## Ground Water Consultants, LLC

September 20, 2022

Re: Review of Aquifer Hydrogeological Report prepared for UW Brazos Valley Farm LLC  
Regarding Well Permit Applications for Barton, Goodland and Harlan Farms in  
Robertson County, Texas

### Supplemental Figure 2 - Simulated Water-Level Difference (10 Year)

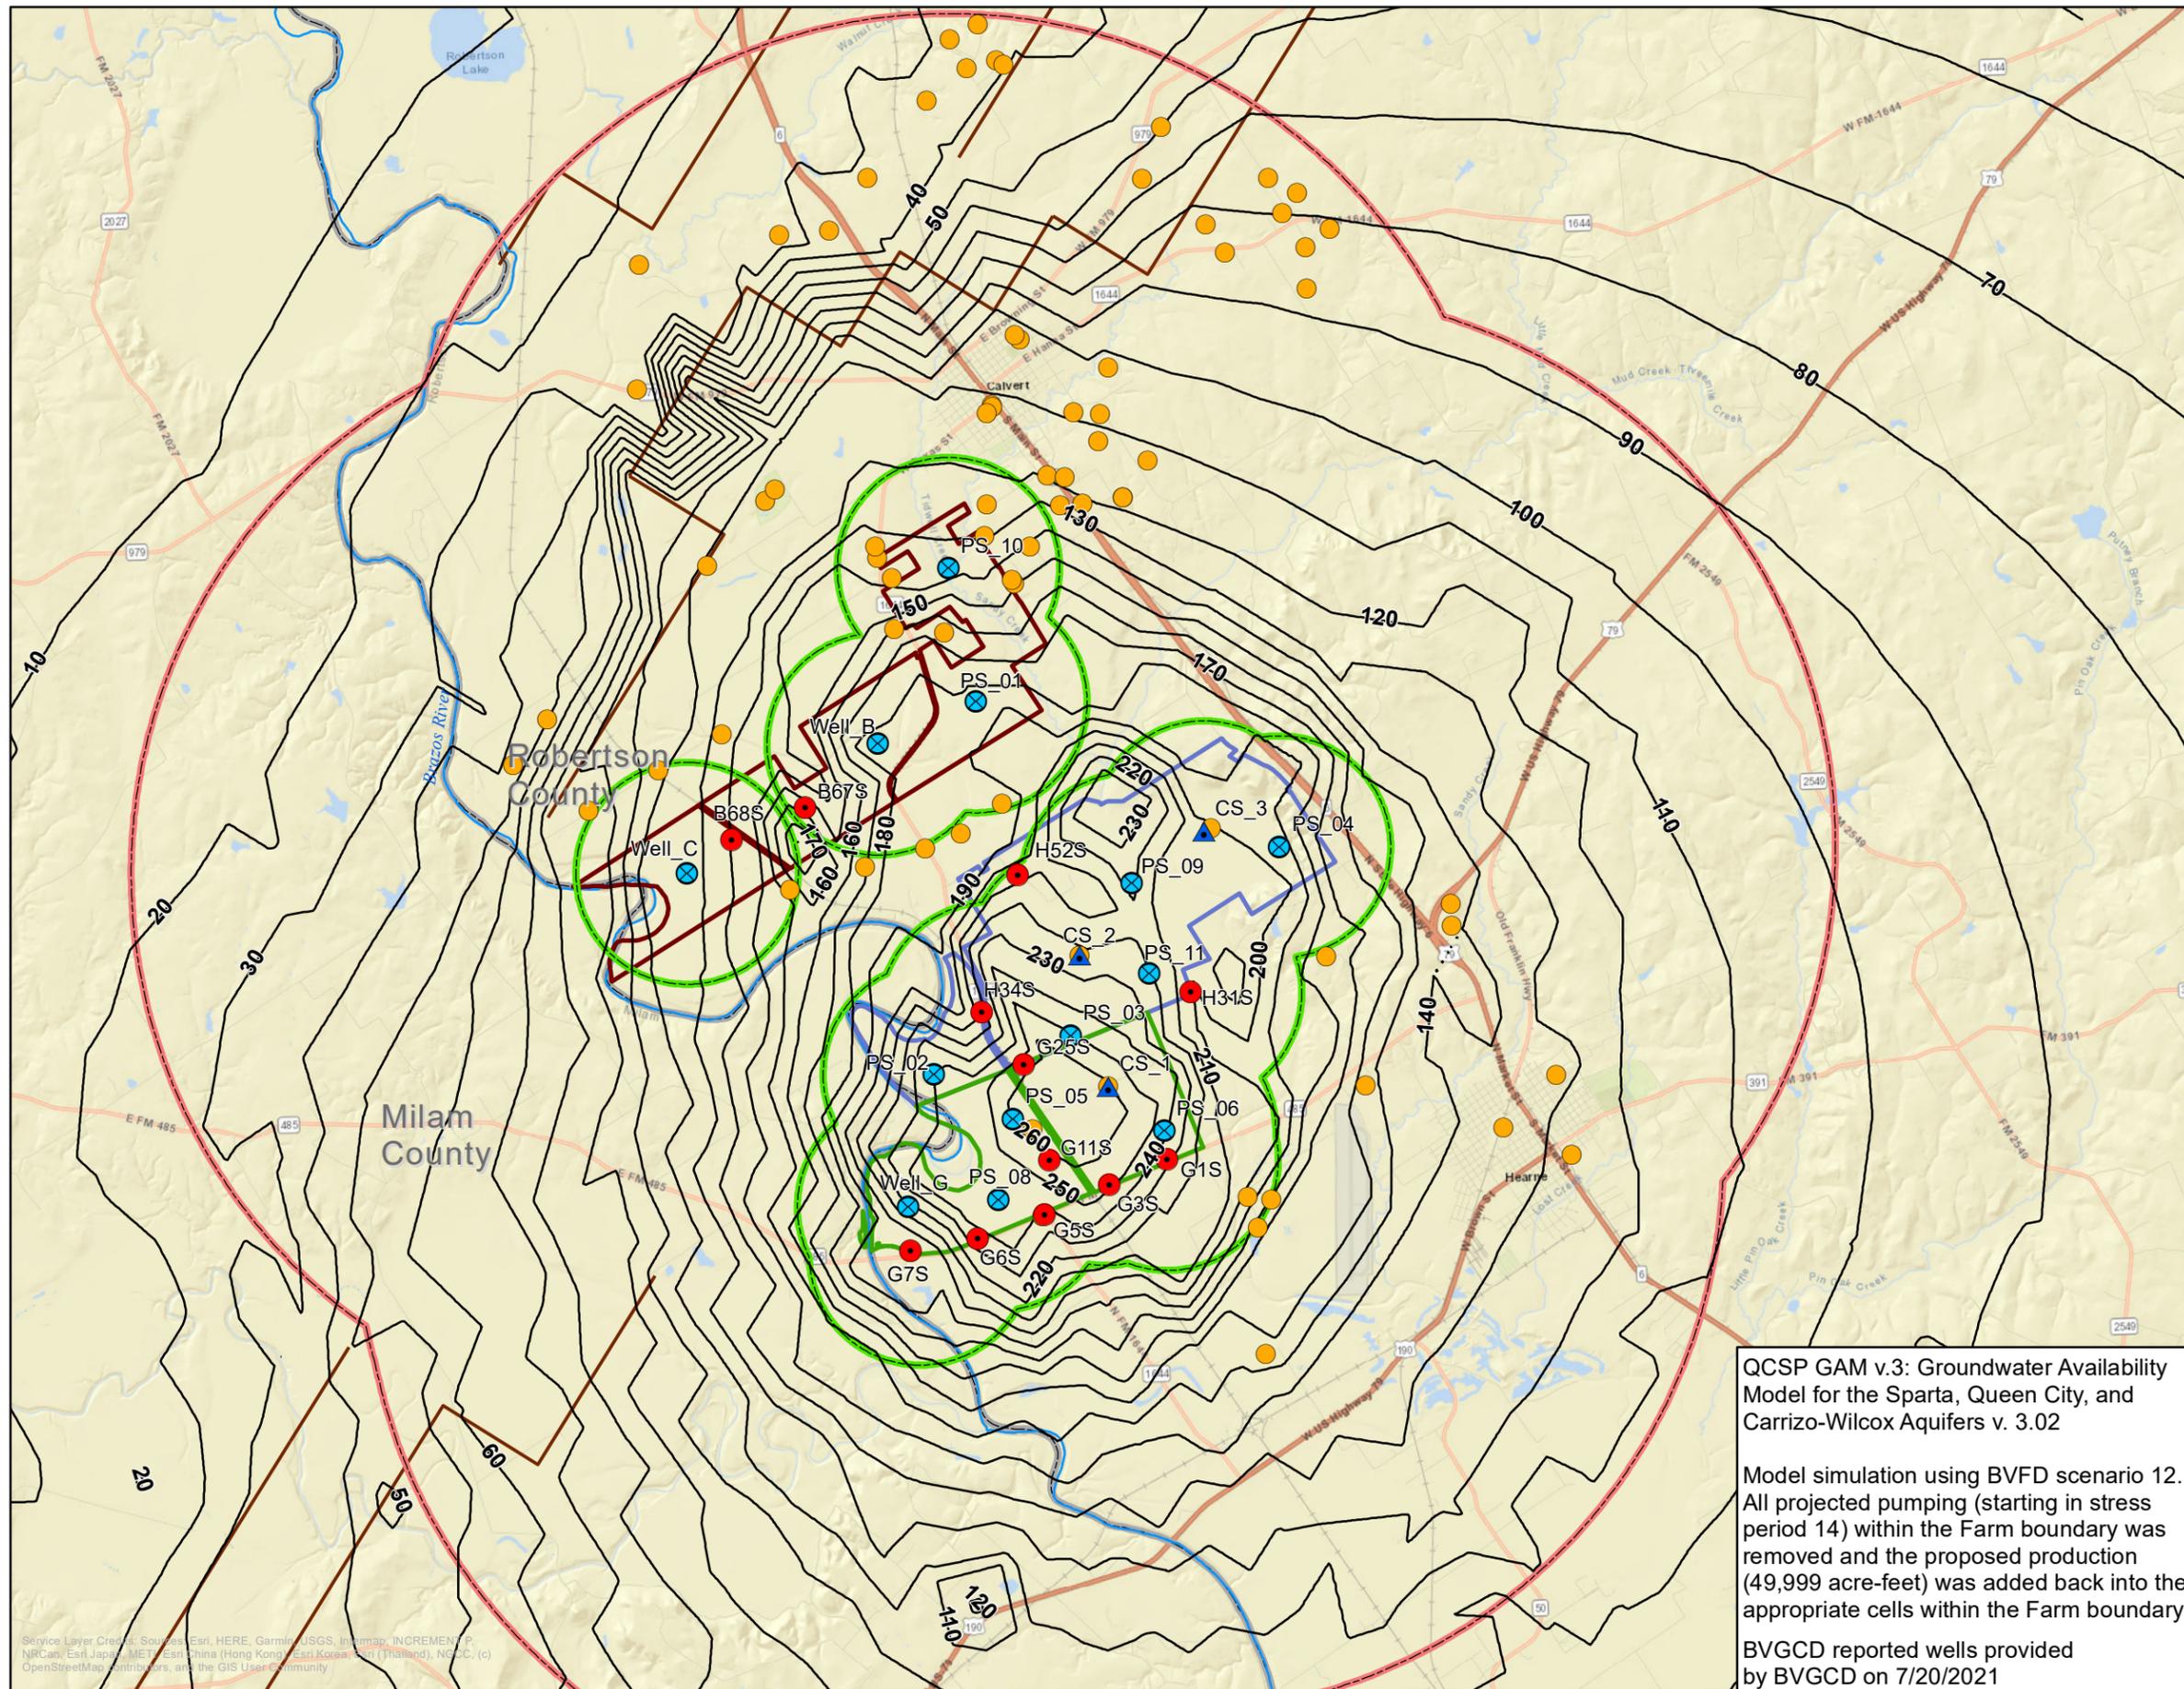
3. As required by Rule 8.4(b)(7)(B)(3), the report includes estimates of the interference drawdown that could be caused by pumping the sixteen wells at an overall rate of 49,999 acre-feet per year for one year and 10 years. The estimates of interference drawdown extend out well over five miles from the wells. The interference drawdown estimates were calculated using the Queen City/Sparta Groundwater Availability Model (GAM) (Young et al 2020) prepared by the Texas Water Development Board(TWDB) The estimated interference drawdown effects using the GAM range from about 80 to 210 feet within one mile of various planned wells on the BVF properties for a pumping period of 10 years. The interference drawdown ranges from about 20 to 110 feet at a distance of five miles depending on the direction from the BVF properties. The GAM estimates of interference drawdown are less toward the Simsboro Aquifer outcrop to the northwest and also are influenced by a fault represented in the GAM that reduces the amount of drawdown estimated to occur on the north side of the fault. A copy of Supplemental Figure 2 is attached showing the modelled interference drawdown estimates after 10 years of pumping at 49,999 ac-ft/yr.

The actual amount of interference drawdown that will result from the pumping should be monitored using data from the District water-level monitoring program.

**Upwell Pumping 49,999 acre feet per year for ten years and resulting drawdown in Simsboro Aquifer**

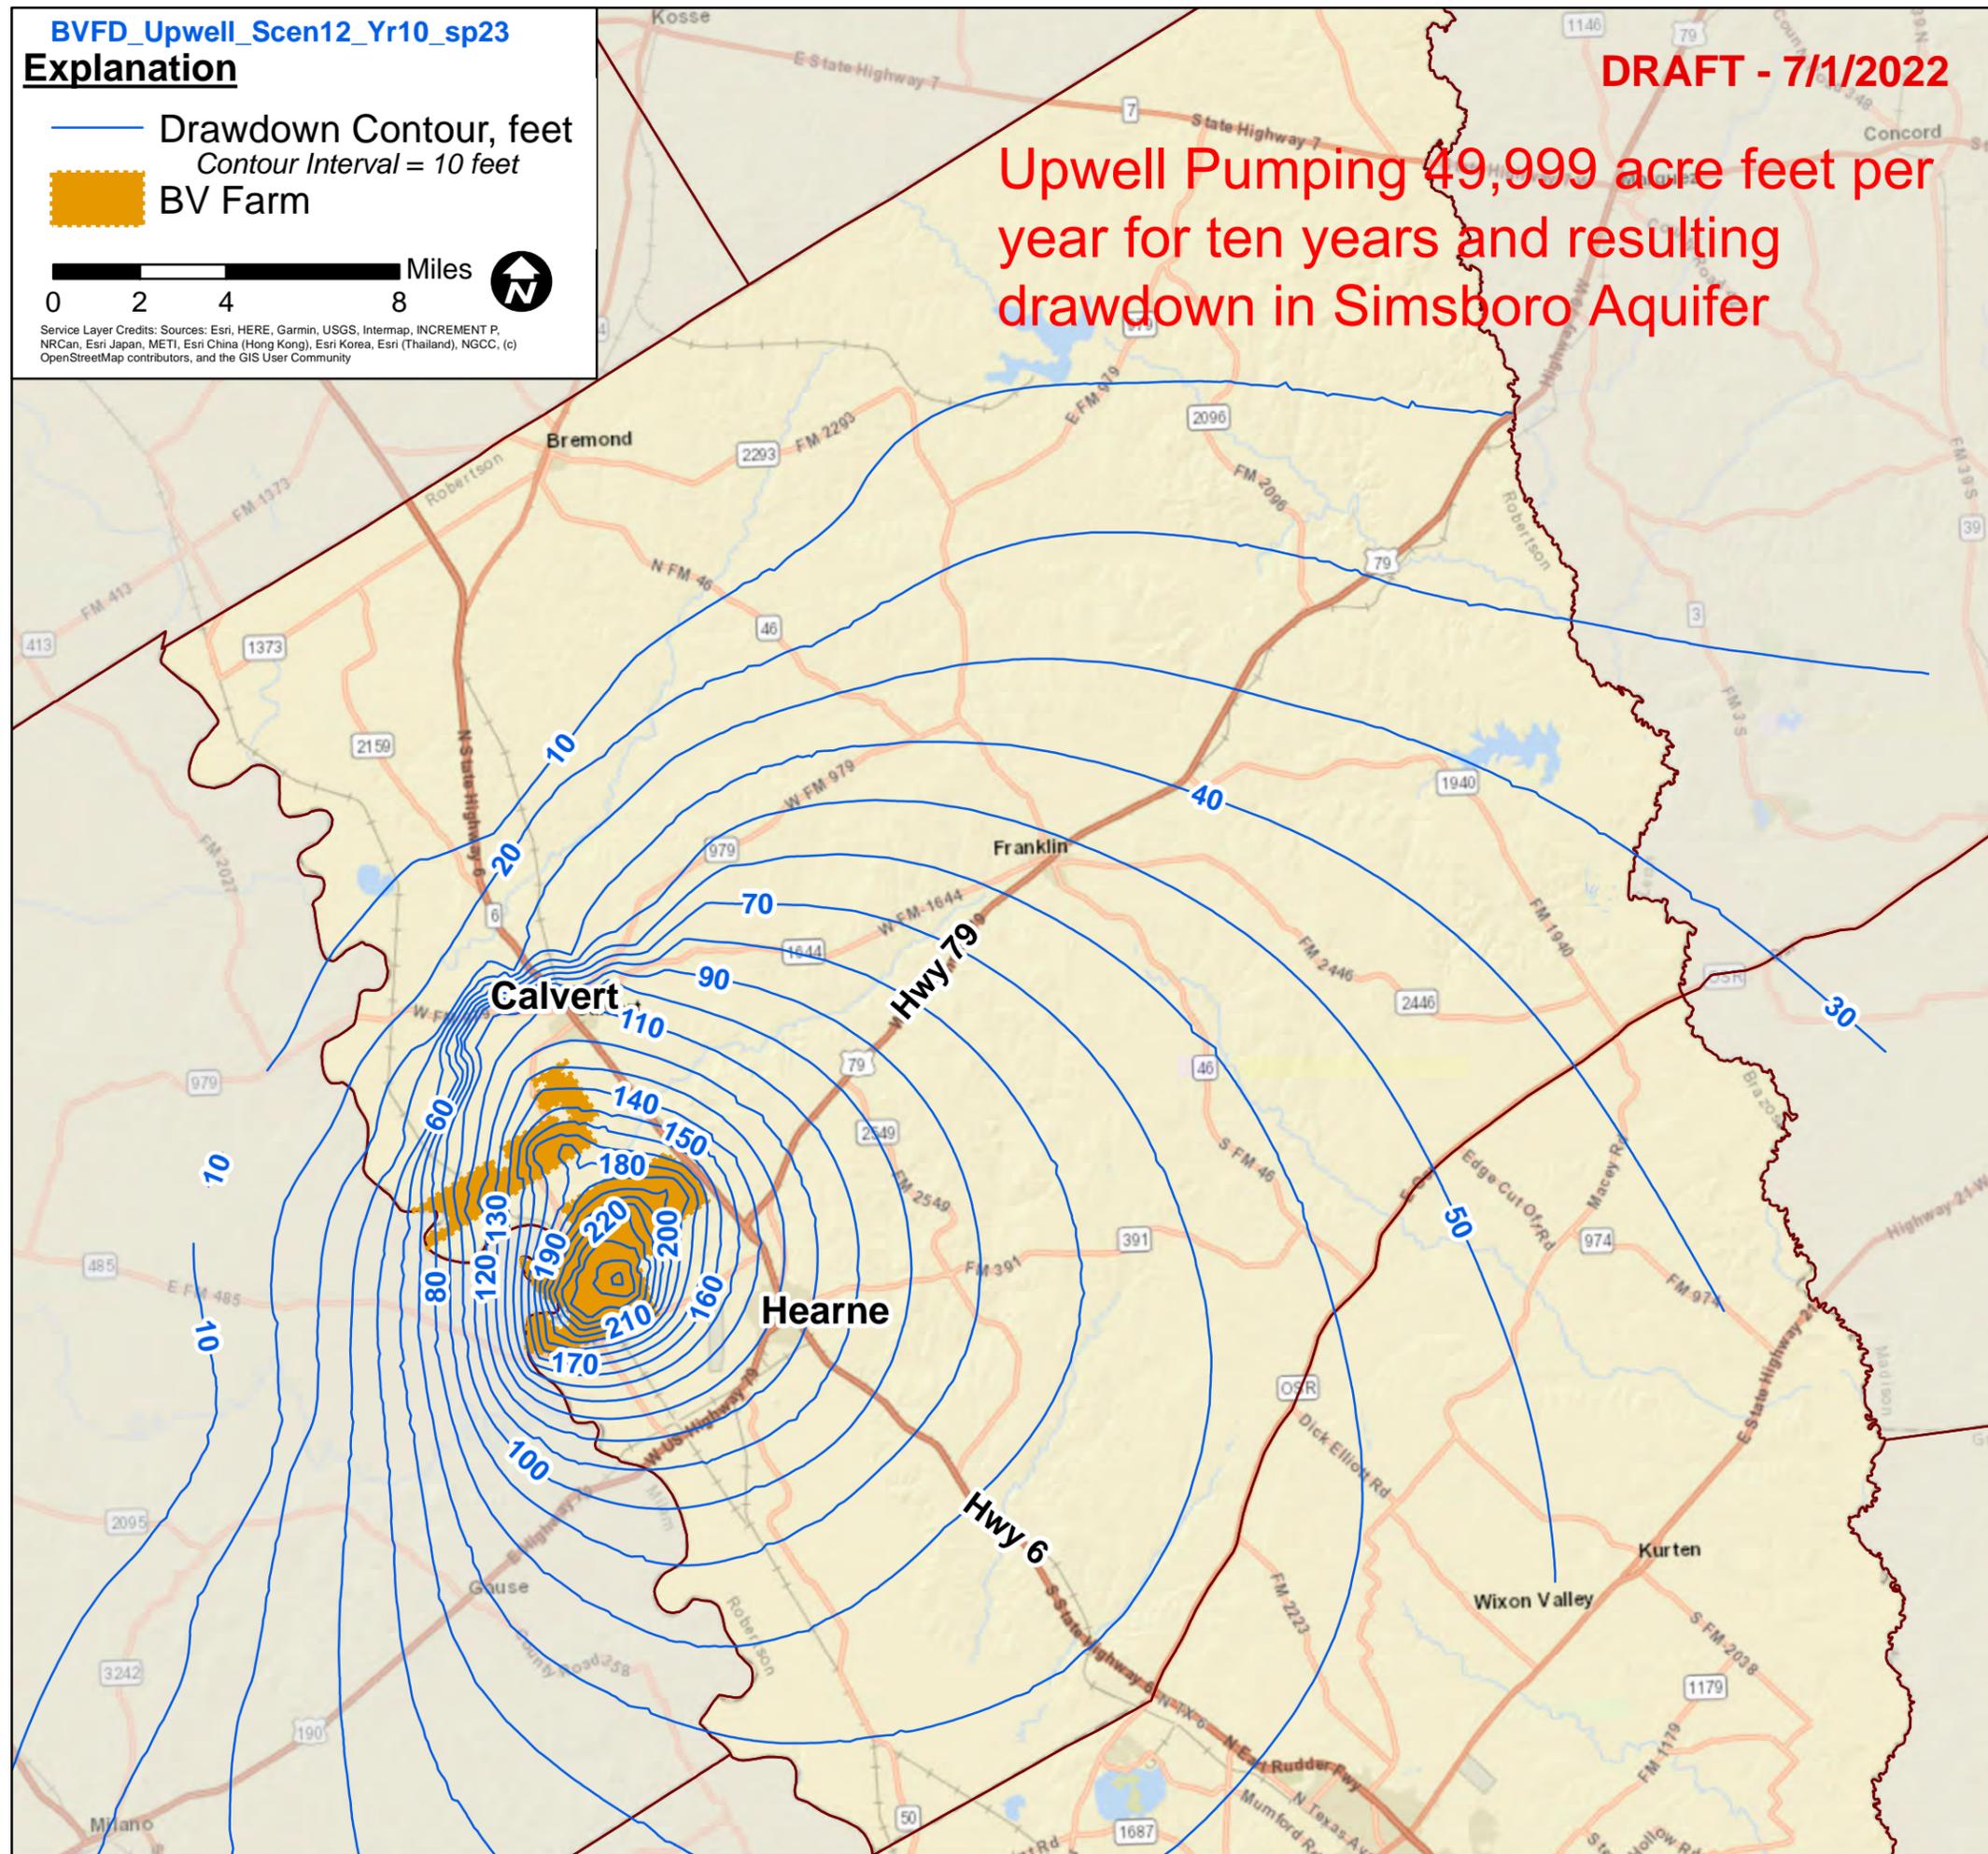
4. Advanced Groundwater Solutions, LLC (AGS) provided modelling support to GWC and performed model simulations with the recently updated Queen City/Sparta GAM, (Young, et al 2020) using the same amounts of pumping in the same locations as in the permit application for the same duration as simulated by TGI and its subconsultant R.W. Harden & Associates and obtained results that were very similar to the results presented by TGI. GWC reserves the right to perform additional model simulations in the future and review the results.
5. The evaluation report, in general, addresses the requirements of Rule 8.4(b)(7)(B).
